**THE SERVICED GRID CODE – ISSUE 5 REVISION 36**

## **THE GRID CODE – ISSUE 5 REVISION 36**

#### **GC0111 – Fast Fault Current Injection specification text**

To update the Grid Code and G99 with revised text for fast fault current injection to dispel any confusion in interpretation of the existing text.

Figure ECC.6.3.16(a)

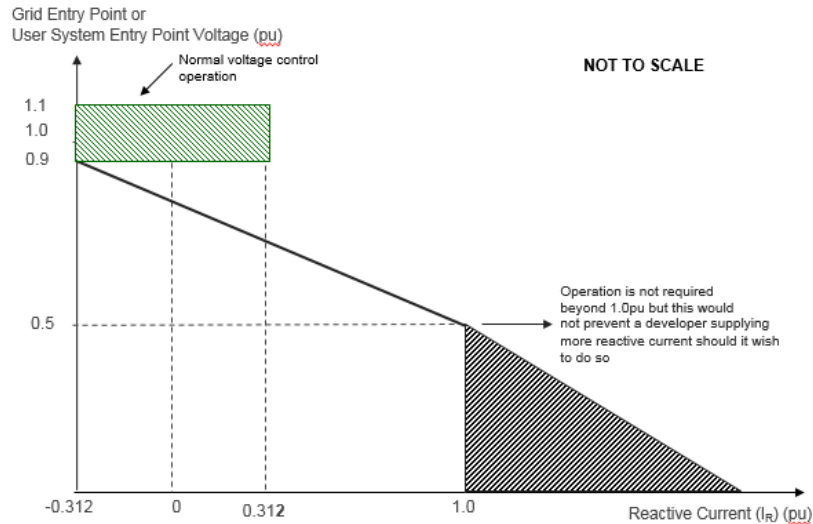
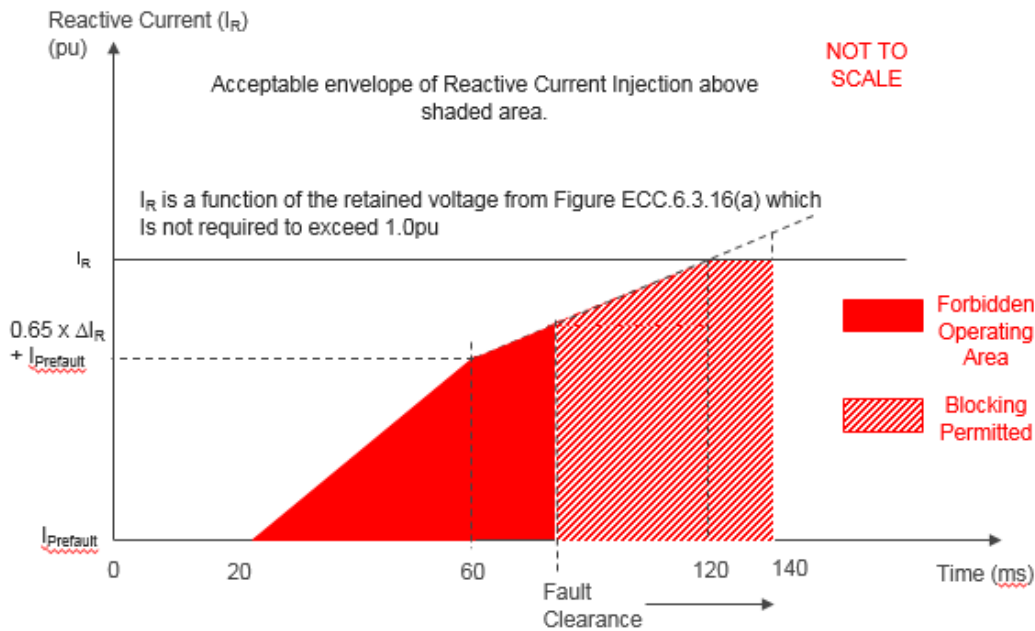
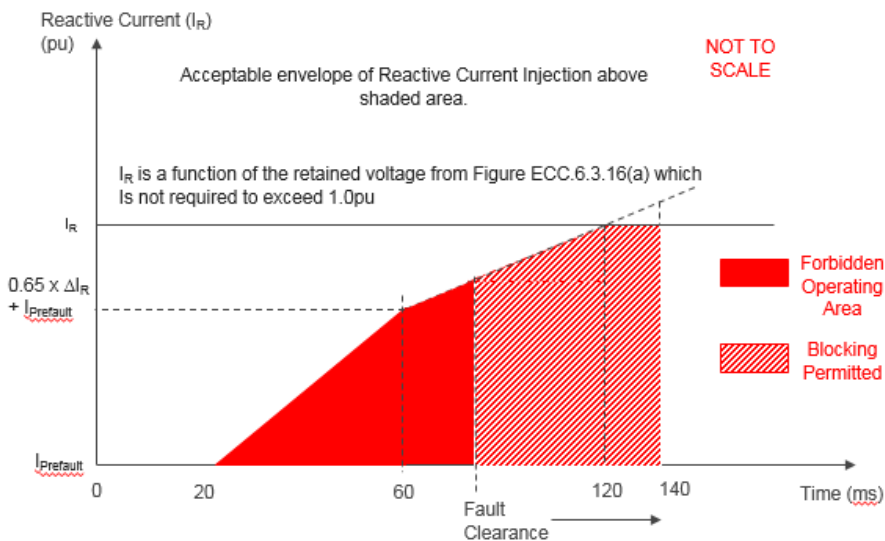
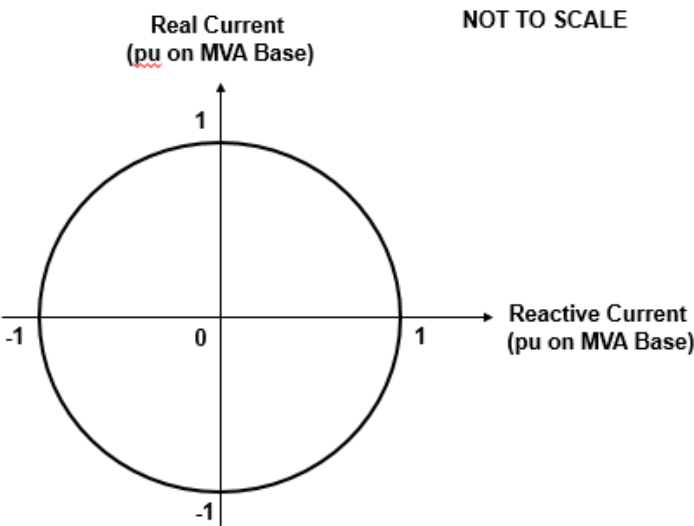
ECC.6.3.16.1.2 For any balanced fault which results in the positive phase sequence voltage falling below the voltage levels specified in ECC.6.1.4 at the **Grid Entry Point** or **User System Entry Point** (if **Embedded**), each **Type B, Type C and Type D Power Park Module** or each **Power Park Unit** within a **Type B, Type C and Type D Power Park Module** or **HVDC Equipment** shall, as a minimum (unless an alternative type registered solution has otherwise been agreed with **The Company**), be required to inject a reactive current above the heavy black line shown in Figure ECC.16.3.16(a)

ECC.6.3.16.1.3 Figure ECC.6.3.16(a) defines the reactive current ( $I_R$ ) to be supplied under a faulted condition which shall be dependent upon the pre-fault operating condition and the retained voltage at the **Grid Entry Point** or **User System Entry Point** voltage. For the avoidance of doubt, each **Power Park Module** (and any constituent element thereof) or **HVDC Equipment**, shall be required to inject a reactive current ( $I_R$ ) which shall be not less than its pre-fault reactive current and which shall as a minimum increase with the fall in the retained voltage each time the voltage at the **Grid Entry Point** or **User System Entry Point** (if **Embedded**) falls below 0.9pu whilst ensuring the overall rating of the **Power Park Module** (or constituent element thereof) or **HVDC Equipment** shall not be exceeded.

ECC.6.3.16.1.4 In addition to the requirements of ECC.6.3.16.1.2 and ECC.6.3.16.1.3, each **Type B**, **Type C** and **Type D Power Park Module** or each **Power Park Unit** within a **Type B**, **Type C** and **Type D Power Park Module** or **HVDC Equipment** shall be required to inject reactive current above the shaded area shown in Figure ECC.6.3.16(b) and Figure ECC.6.3.16(c) which illustrates how the reactive current shall be injected over time from fault inception in which the value of  $I_R$  is determined from Figure ECC.6.3.16(a). In figures ECC.6.3.16(b) and ECC.6.3.16(c)  $\Delta I_R$  is the value of the reactive current ( $I_R$ ) less the pre-fault current. In this context fault inception is taken to be when the voltage at the **Grid Entry Point** or **User System Entry Point** falls below 0.9pu.

ECC.6.3.16.1.5 The injected reactive current ( $I_R$ ) shall be above the shaded area shown in Figure ECC.6.3.16(b) and Figure ECC.6.3.16(c) with priority being given to reactive current injection with any residual capability being supplied as active current. Under any faulted condition, where the voltage falls outside the limits specified in ECC.6.1.4, there would be no requirement for each **Power Park Module** or constituent **Power Park Unit** or **HVDC Equipment** to exceed its transient or steady state rating of 1.0 pu as defined in ECC.6.3.16.1.7.
